AGENDA
President and Board of Trustees
Village of Arlington Heights
Board Room

Arlington Heights Village Hall
33 S. Arlington Heights Road
Arlington Heights, IL 60005
March 6, 2023
7:30 PM

B. Windsor School Building Expansion - 1315 E. Miner St. - PC#22-021
Amendment to SUP Ord #90-082 and #17-013 for Building Addition, Amendment to the Comprehensive Plan from Parks to Schools

Sheet No:
CX1.1

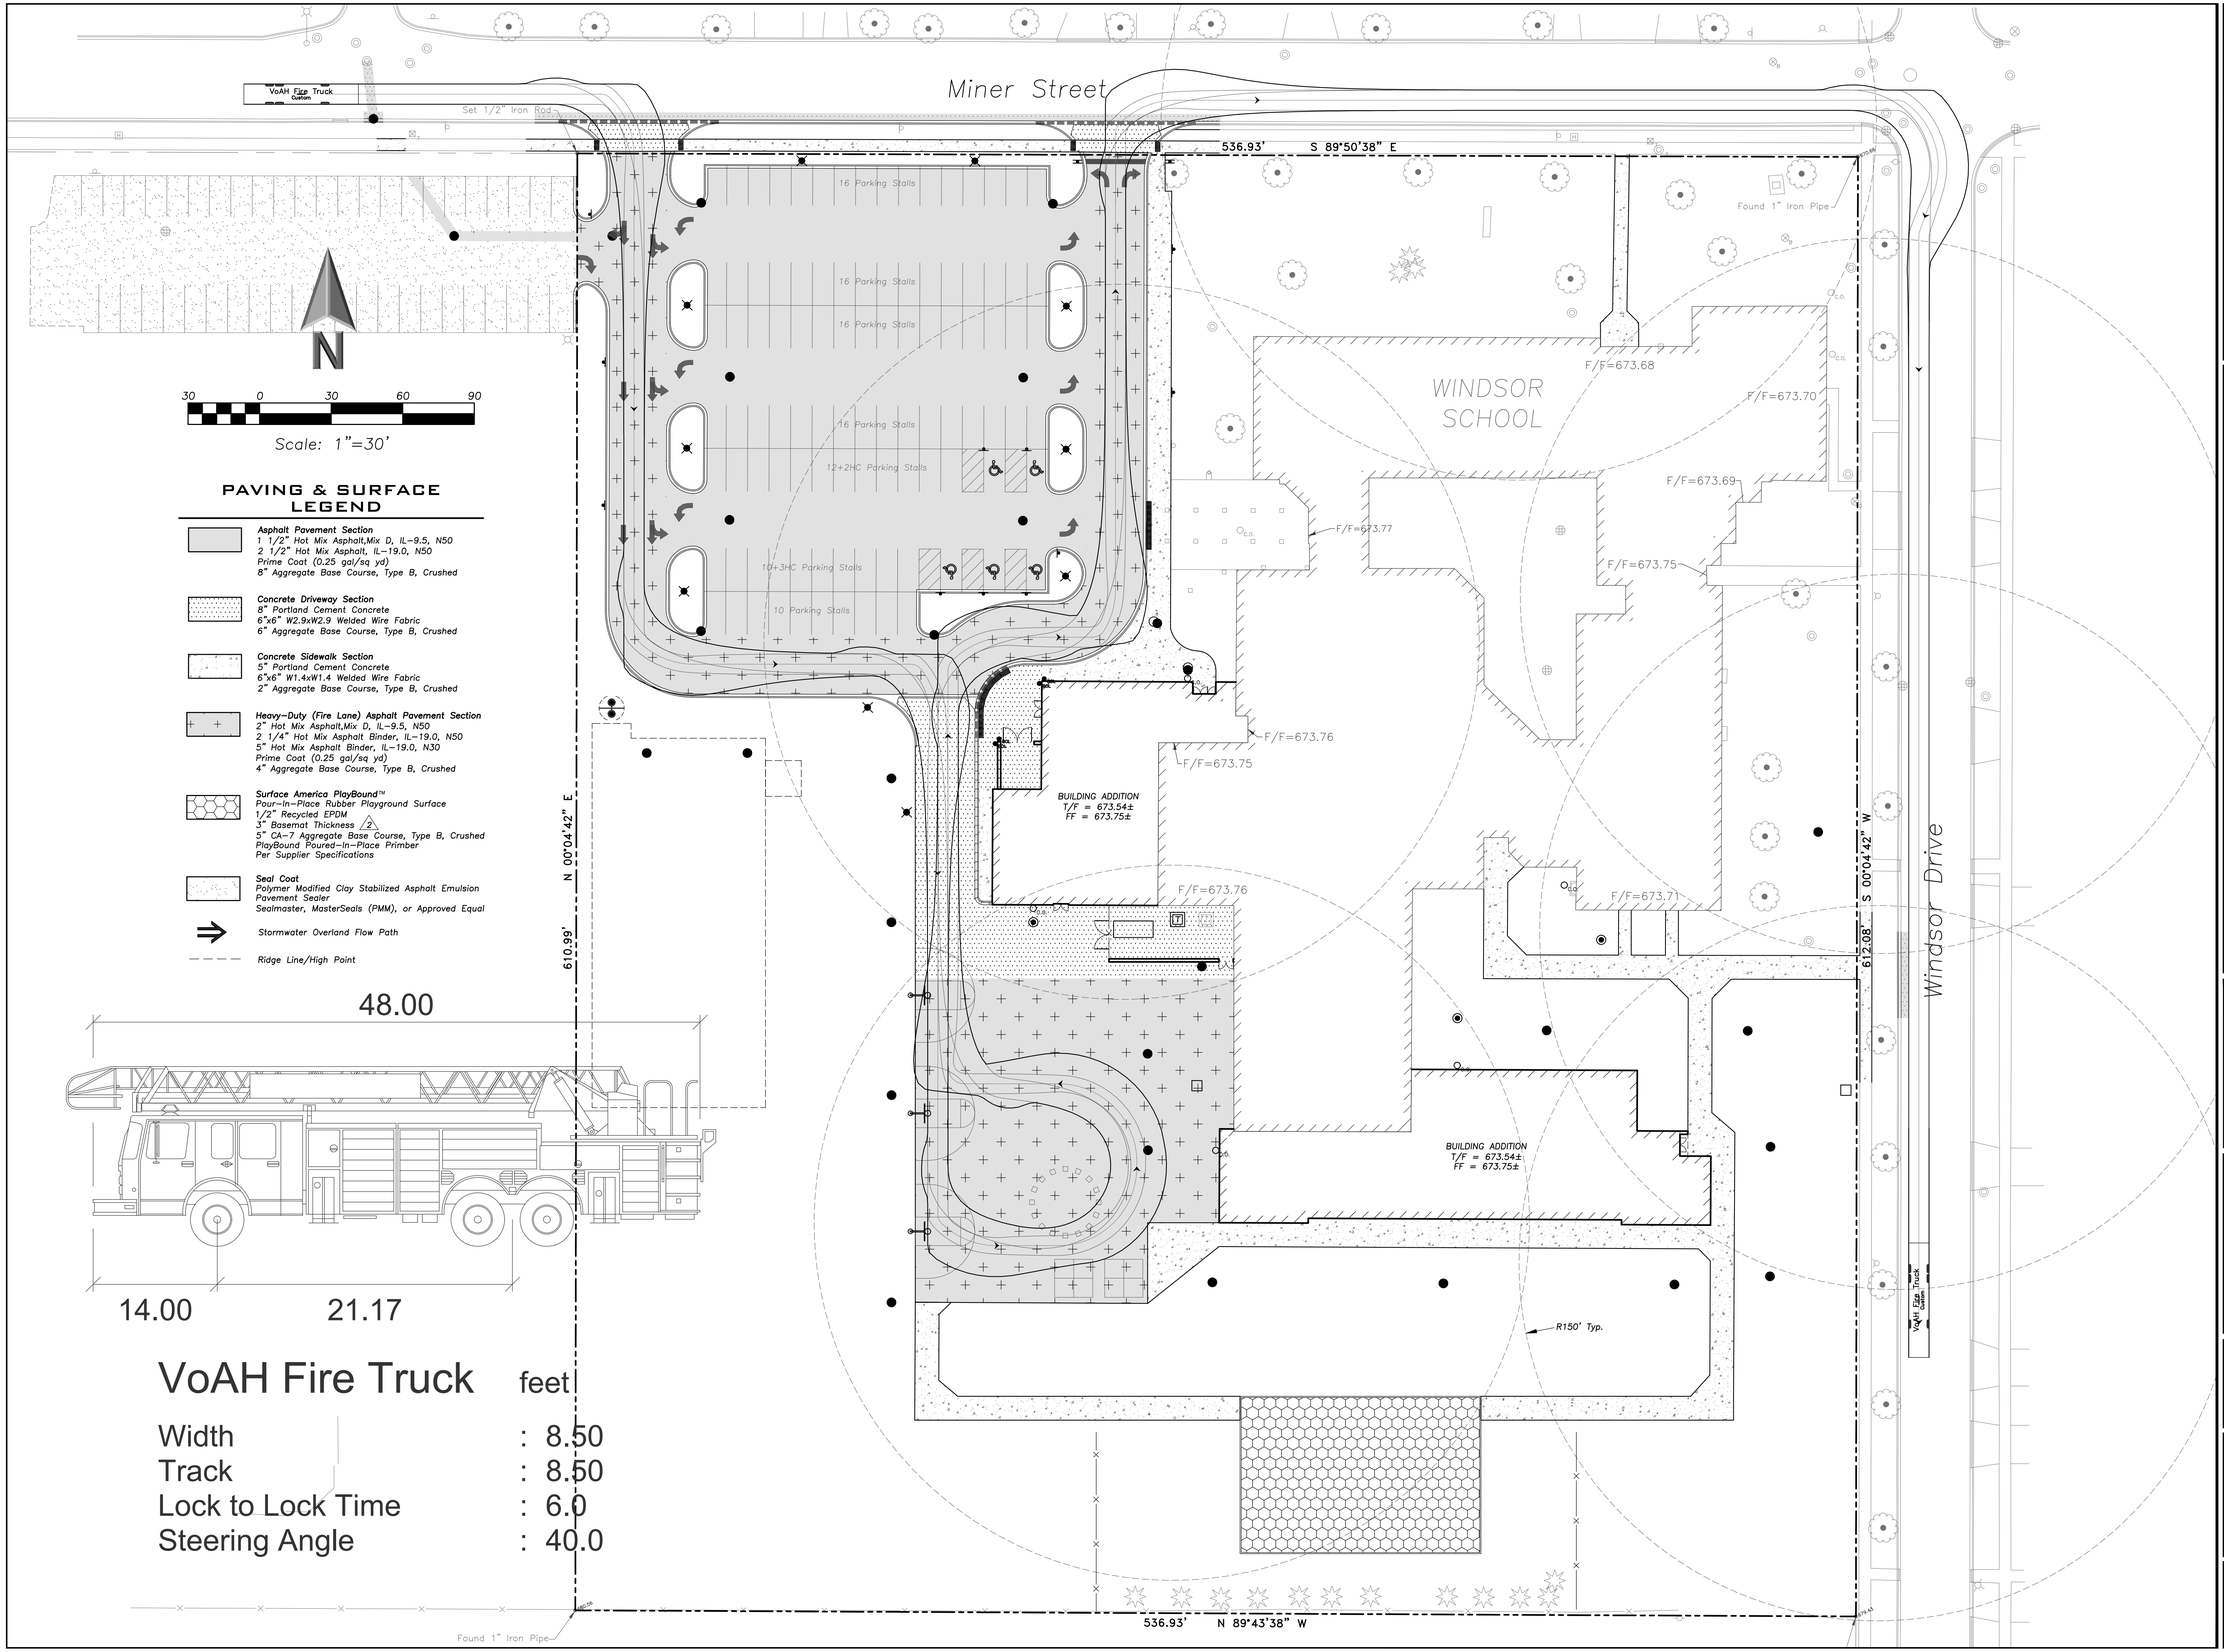
16. On sheet C 101 Site Demolition Plan, the utilities to be removed do not correlate with the utilities shown on sheet C00l Topographical Survey. Verify the existing utilities.

RESPONSE: Please see exhibit CX1.1 showing the approved fire access and dimensions from the submitted plans in 2017.
